PCI-SIG ENGINEERING CHANGE NOTICE

TITLE:	Separate Refclk Independent SSC Architecture (SRIS)
DATE:	Updated 10 January 2013
AFFECTED DOCUMENT:	PCI Express Base Spec. Rev. 3.0
SPONSOR:	Intel, HP, AMD

[Figure 4-x0: Swept Sj Mask](#)

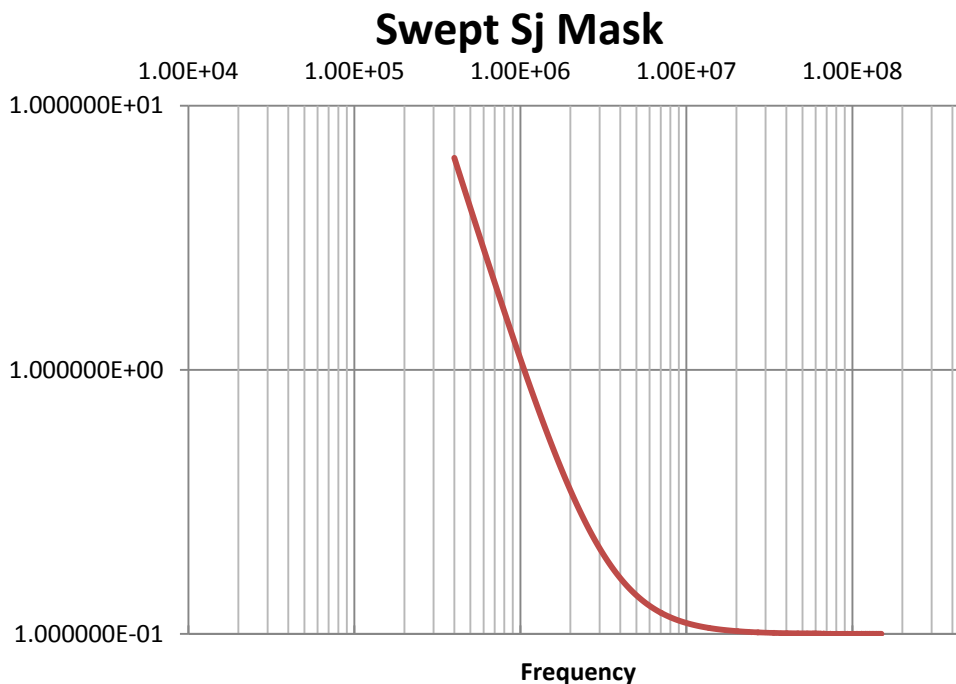
- The DUT shall be driven with an independent SSC modulated reference clock for all testing. SSC shall meet the frequency limits and maximum deviation range defined in table 4-34.
- The generator shall be driven with an independent SSC modulated reference clock for the stressed voltage test. SSC shall have a triangular profile and meet the frequency limits and maximum deviation range defined in table 4-34.
- The generator shall provide a 33 kHz S_j tone with 25 ns peak to peak amplitude during the stressed eye test.
- The generator shall transmit with a nominal unit interval of 125 ps + 2500 PPM during the stressed eye test.
- S_j shall be swept over the range shown in Figure 4-x0 during the stressed eye test:

Figure 4-92: Separate Refclk [With No SSC \(SRNS\)](#) Architecture

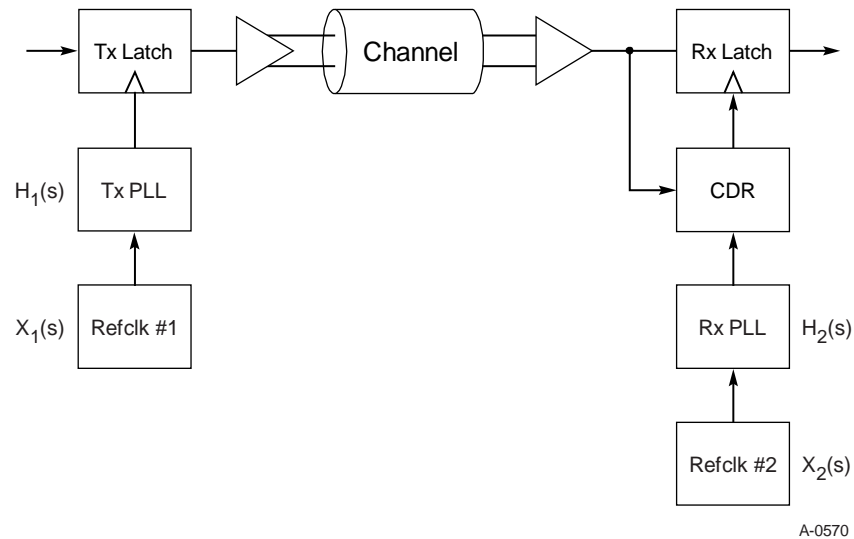
It is also possible to architect a PCI Express implementation with separate Refclk sources for the Tx and Rx. Since this architecture employs two independent clock sources, the amount of jitter impinging on the Receiver is the RSS sum, rather than the difference of the PLL transfer characteristics. As a consequence, the jitter requirements for the Refclks in a separate Refclk architecture are substantially tighter than for a common Refclk Rx architecture. Furthermore, it is not in general possible to guarantee interoperability between separate Refclk architecture components and those using other clock architectures. [This specification does not explicitly define the requirements for separate Refclk architecture, but instead will defer to the appropriate form factor specification.](#)

When tolerancing a PCI Express Rx in [this](#) separate Refclk architecture, the generator and DUT are furnished with separate Refclks that each are within ± 300 PPM of the nominal frequency of 100 MHz. SSC must be turned off for both Refclk sources. These limitations are required to guarantee proper operation of the buffering and flow control in the Rx.

Figure 4-92a: Separate Refclk With Independent SSC Architecture

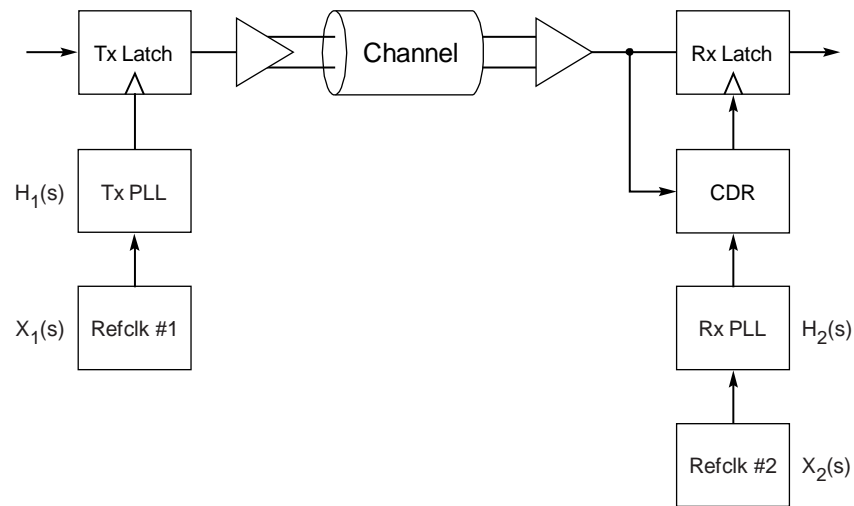
[It is also possible to architect a PCI Express implementation with separate Refclk sources with independent SSC for the Tx and Rx. This architecture employs two independent clock sources each having independent spread spectrum clocking \(SSC\). The Receiver must be able to track and reject the resultant phase drift between the Tx and Rx. Changes in the logical sub-block are also required for this separate Refclk with Independent SSC architecture; refer](#)

Figure 4-92a below shows the block diagram of the separate Refclk architecture. Since Refclk #1 and Refclk #2 are independent from each other, their respective jitter at the Rx Latch are simply $X_1(s) \cdot H_1(s) \cdot H_{CDR}(s)$ and $X_2(s) \cdot H_2(s) \cdot H_{CDR}(s)$; where $H_{CDR}(s)$ is the CDR's jitter transfer function. However, since Refclk jitter is primarily R_j , their combined impact should be the Root Sum Square (RSS) of the individual terms.

Figure 4-x1: Informative CDR Jitter Transfer Function for the Separate Refclk with Independent SSC (SRIS) Architecture at 5.0 GT/s

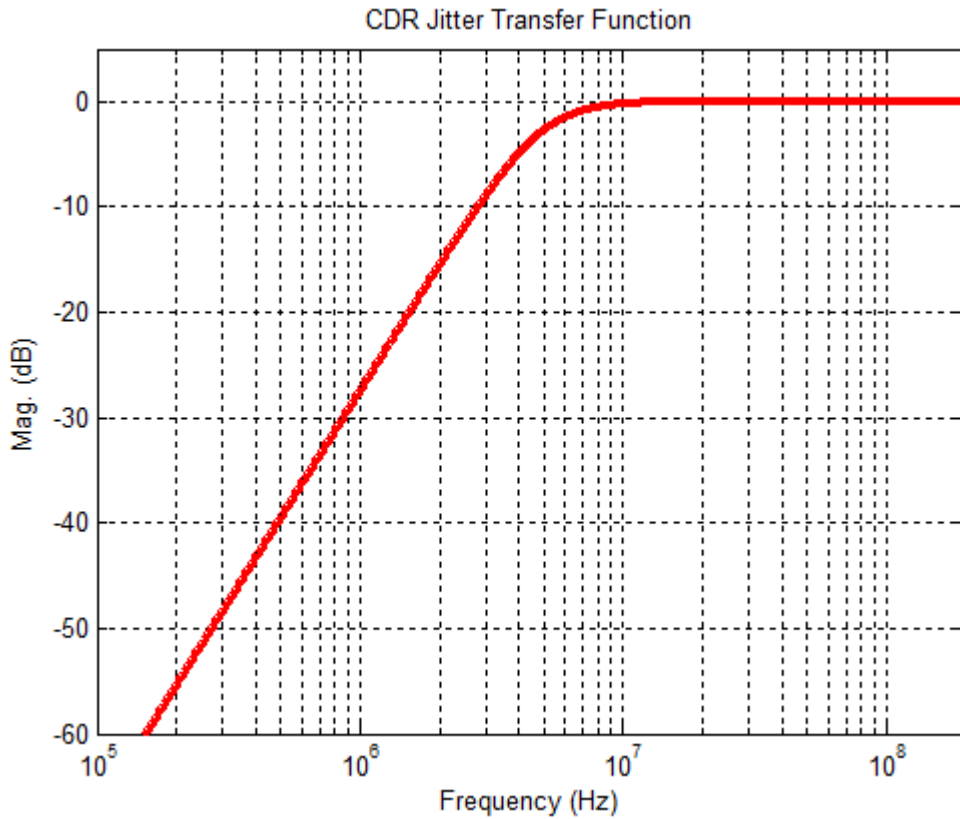
For the separate Refclk with independent SSC architecture, the informative CDR jitter transfer function is a second order high-pass function with the -3 dB corner frequency at 5 MHz, see Figure 4-9x1 and Equation 4.3.7.

$$H_{JTF}(s) = \frac{s^2}{s^2 + 2\zeta\omega_m s + \omega_m^2}$$

where $f_m = \frac{2 * 5.0 \text{ MHz}}{\sqrt{1 + 2\zeta^2 + \sqrt{1 + (1 + 2\zeta^2)^2}}}$ $\zeta = .707$ and $\omega_m = 2\pi f_m$

Figure 4-9x2: Informative CDR Jitter Transfer Function for the Separate Refclk With Independent SSC (SRIS) Architecture at 8.0 GT/s

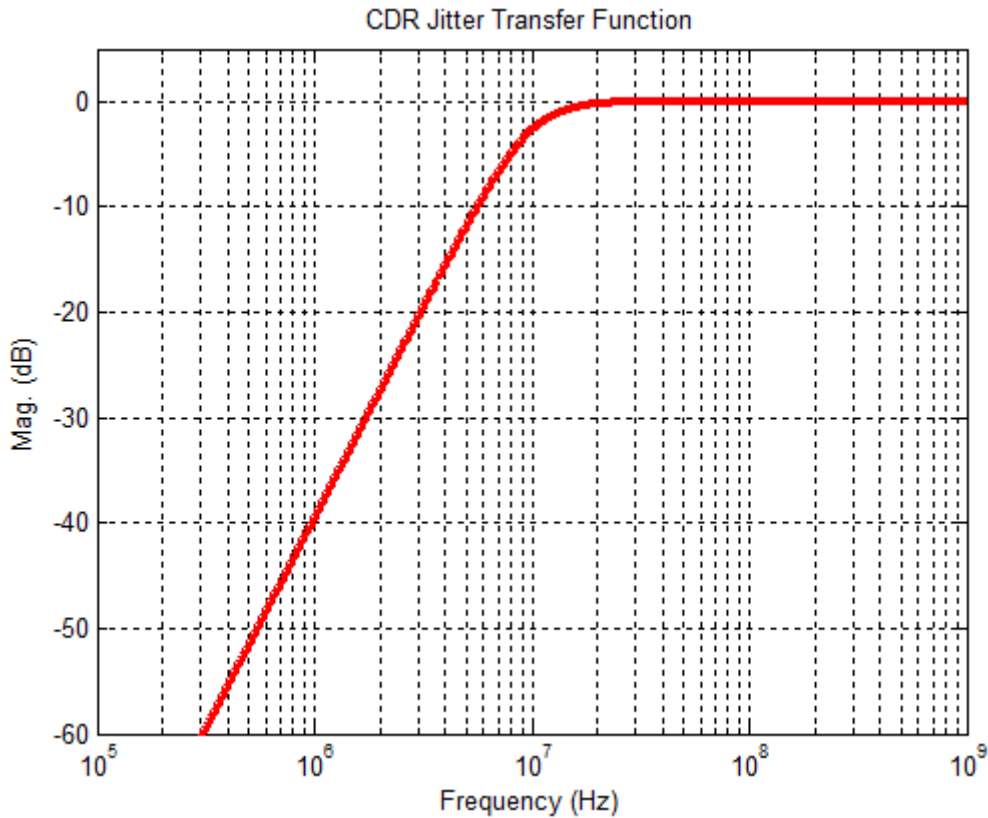
For the common Refclk architecture, the 8.0 GT/s specification contains a behavioral CDR model shown in Figure 4-67; it is a first order high-pass function with the -3dB corner frequency at 10MHz. Furthermore, during the receiver stressed jitter test (section 4.3.4.4), the receiver's CDR bandwidth and its low frequency jitter tracking capability are required to pass the jitter mask (Figure 4-74). For the separate Refclk with independent SSC architecture, the CDR needs to have a second order high-pass behavior to reject the extra phase drift due to independent SSC. This new behavioral CDR jitter transfer function is shown in Figure 4-9x2 and Equation 4.3.8. The stressed jitter test is also modified to account for the requirement that the CDR can reject jitter from two separate reference clocks with SSC. Other test parameters and requirements such as transmitter jitters (Table 4-19) and the receive stressed voltage eye (Table 4-22) remain unchanged.

$$H_{JTF}(s) = \frac{s^2}{s^2 + 2\zeta\omega_m s + \omega_m^2} \quad \text{Equation 4.3.8}$$

$$\text{where } f_m = \frac{2 \cdot 10.0 \text{ MHz}}{\sqrt{1 + 2\zeta^2 + \sqrt{1 + (1 + 2\zeta^2)^2}}} \quad \zeta = .707 \text{ and } \omega_m = 2\pi f_m$$
